Report to Joseph Rowntree Housing Trust

Project Title: Temple Avenue Project Part 1

Temple Avenue field trial – Evaluation of design & construction process and measurement of fabric performance of new build dwellings

Figure 1 Potential thermal bypass in the A1 prototype (from the architects' drawing 2154_100).

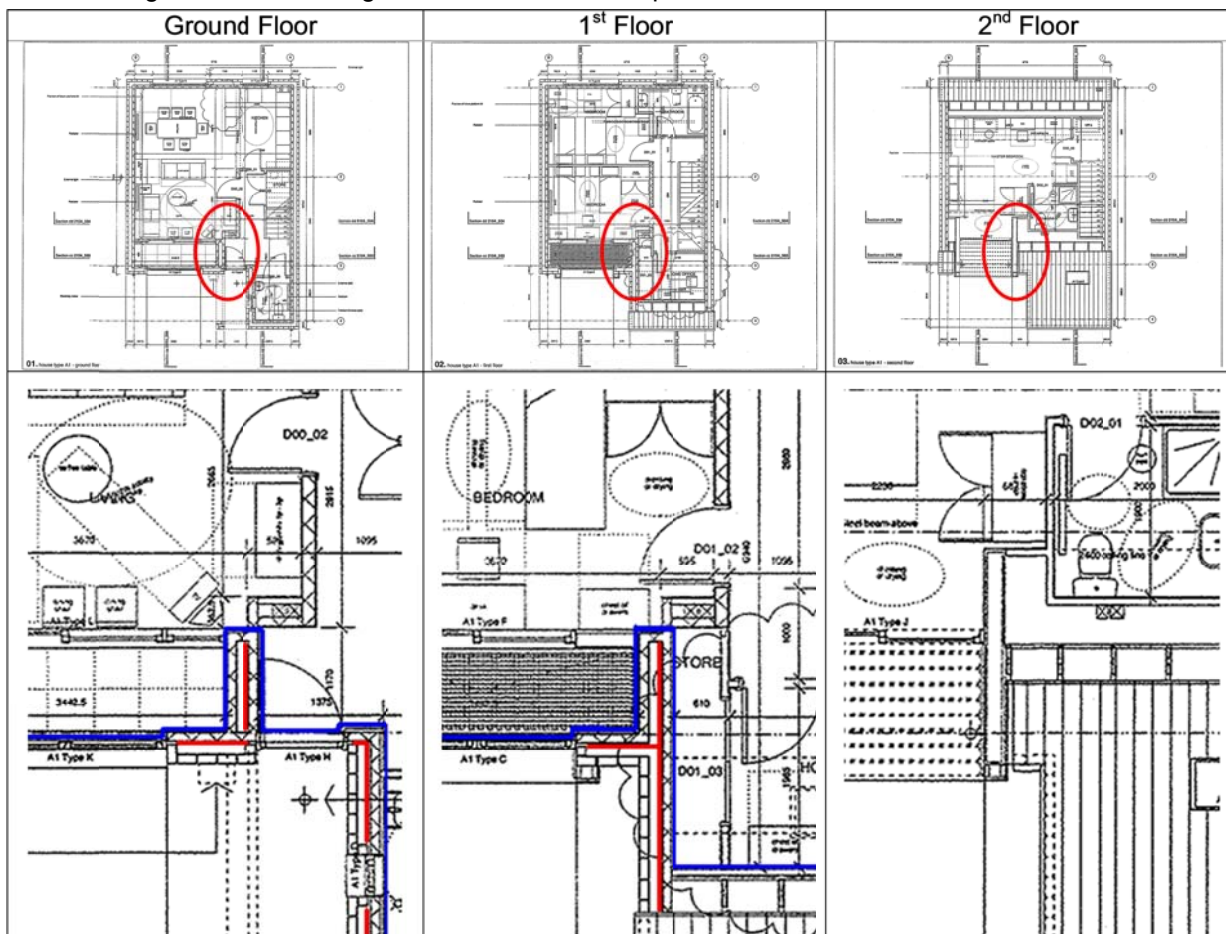
- 9 Some design issues were resolved on site following discussions between the site and design staff. Thermal bypasses arise where the air barrier and insulation layer have become separated. The potential thermal bypass in the A1 (masonry) prototype, in the area ringed in Figure 1, linked the void beneath the ground floor to the roof void; it was resolved by fully filling the void with insulation and a membrane used to ensure that the top of the void was closed off before it linked to either the roof void or the intermediate floor void. This solution was agreed between the architect and site manager after discussing a number of different options.

Figure 4 The adapted mortar scoop, on the left, with the 2 outer teeth removed from each side.

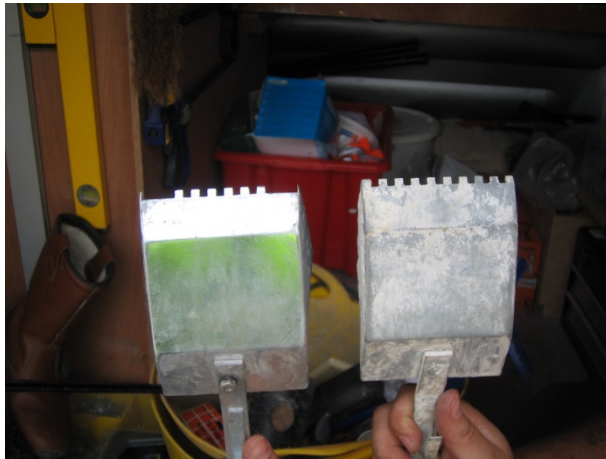
- 18 The mortar scoop was adapted to provide mortar at the edges of perpend and bedding layers (Figure 4) after comments that the joints didn't look full because there was no excess mortar at the edges that required striking off. Additional work was created in removing the excess mortar with an abrasive tool prior to both applying the wall insulation externally and the parge layer internally. Using the abrasive plate, rather than just striking off, removed the powdery surface layer which had caused a problem with tape adhesion to un-parged blockwork; instead it left a dusty residue on the blockwork which presented new adhesion problems.

- 70 The scoop adaptation made to provide excess blockwork adhesive on the internal and external surfaces of the blockwork created additional work, in that this had to be removed using an abrasive plate before applying the parging and cavity wall insulation. This seemed to be slightly unnecessary as the parge coat would be filling any gaps on the internal blockwork anyway, but it may have assisted in reducing any gaps between the external face of the blockwork and the wall insulation.

Figure 6 Adapted from drawing 2154_820, a comparison between the as-designed (left) and as-constructed (right) sole plate detail.

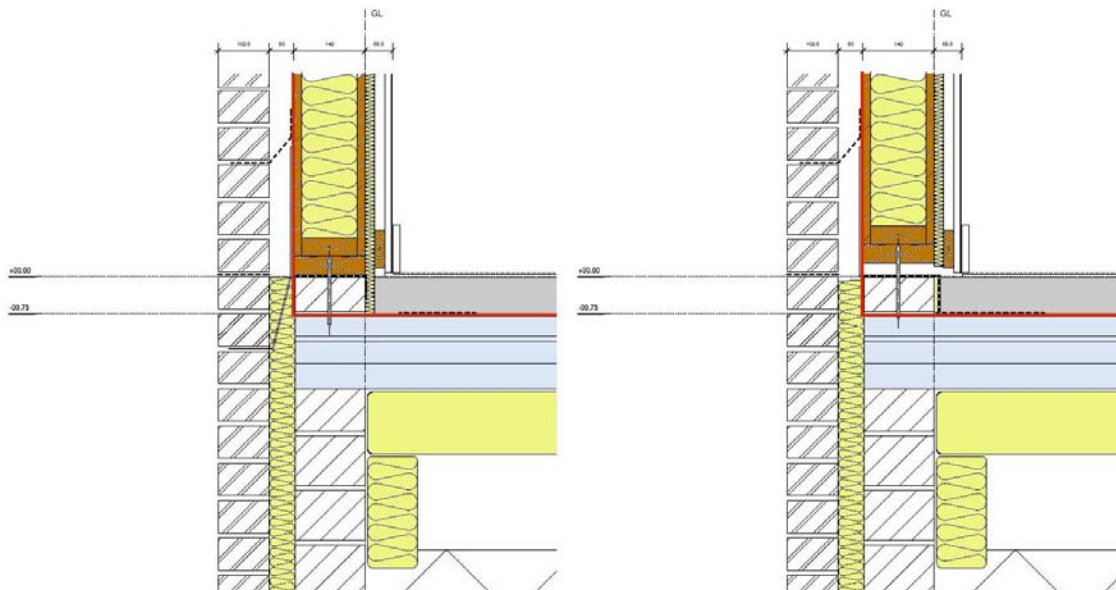
- 24 There were a number of issues regarding the detailing at the slab perimeter and sole plate including levelling and grouting of the sole plate, slab perimeter insulation performance and insulation continuity, and fixing and linking of various membranes. Figure 6 shows the variation between the as-built and as-designed detail, the gap illustrated beneath the sole plate in the as-built detail being filled with an injectable grout.

- a) The SIPs system manufacturer’s BBA certificate indicates that there should be an injectable grout between the sole plate and slab where spacers/shims are required to level the soleplate, the designs showed no gap between the sole plate and slab so no such grout appeared on the design. The main contractors were responsible for grouting the gap between the sole plate and floor and received details of the recommended material from the SIPs system manufacturer. This gap varied from 0 to >30mm in places. The grouting was delayed until after 20mm internal insulation had been installed, making job much more difficult to perform successfully.

- 67 The continuation of the 20mm internal insulation lining of the external walls down to the base of the floor slab to provide slab perimeter insulation is not buildable due to sequencing issues. The use of 10mm expanded polystyrene expansion strip at the slab perimeter as a suitable substitute needs to be fully assessed, particularly at the front and rear elevations where the underfloor vents replace the full fill insulation boards in the cavity below floor level. Increasing the height of the full fill insulation boards to above the top of the sole plate could mitigate any thermal bridging at this junction, or alternatively review the floor construction process to enable the 20mm perimeter insulation to be successfully installed.

- The need to use plastic spacers/shims and a retro-fitted grout to level and seal beneath the sole plate created both airtightness and thermal bridging issues which could have been avoided if the slab perimeter was level and a gasket system employed. With laser levelling and modern techniques the level of tolerance required for this is achievable; the only remaining question may be whether it would prove cost-prohibitive.

Figure 9 The original membrane in the A1 prototype between the lounge and sunspace, shown failing during the pressure test, being removed and a replacement installed.

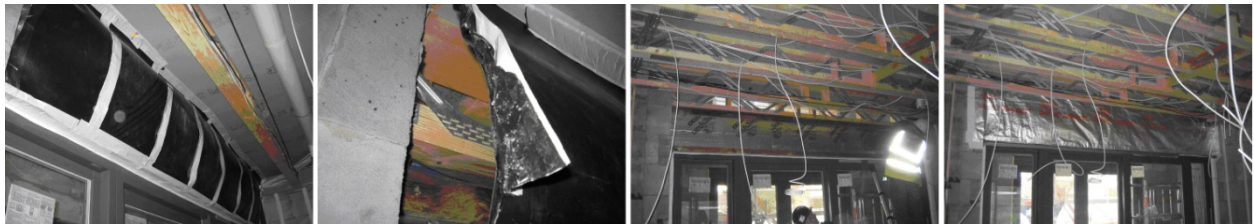
- 22 The membrane above lounge front windows which formed the air barrier between the frame and the intermediate floor was originally made up on site using strips of a stiff dpm-type membrane, as this was material readily available on site and had also been used to wrap around the exposed edge of the intermediate floor at the sunspace. Using materials already present on site is a common construction practice to attempt to save time and money but in this case it resulted in the membrane having to be removed and replaced with a more suitable material at a later date.

- 30 In the initial test (19/10/09) on the masonry prototype a mean air permeability of 5.87 m³/(h.m²)@50Pa was achieved. The majority of the air leakage appeared to be around, through and between the air barrier membranes in the sloping roof sections. The air tightness at this detail appeared to deteriorate as the test and subsequent leakage detection progressed; the failure of some of the adhesive tape used indicating that it was clearly not suitable for this purpose. In fact, the test, itself, had to be halted and restarted to allow the replacement of the air barrier, with a more suitable material, above the ground floor doors into the sunspace (Figure 9). Further air leakage paths identified included:
- At the ground floor wall junction, particularly at the room corners.
 - At electrical penetrations through the blockwork and airtightness membrane.
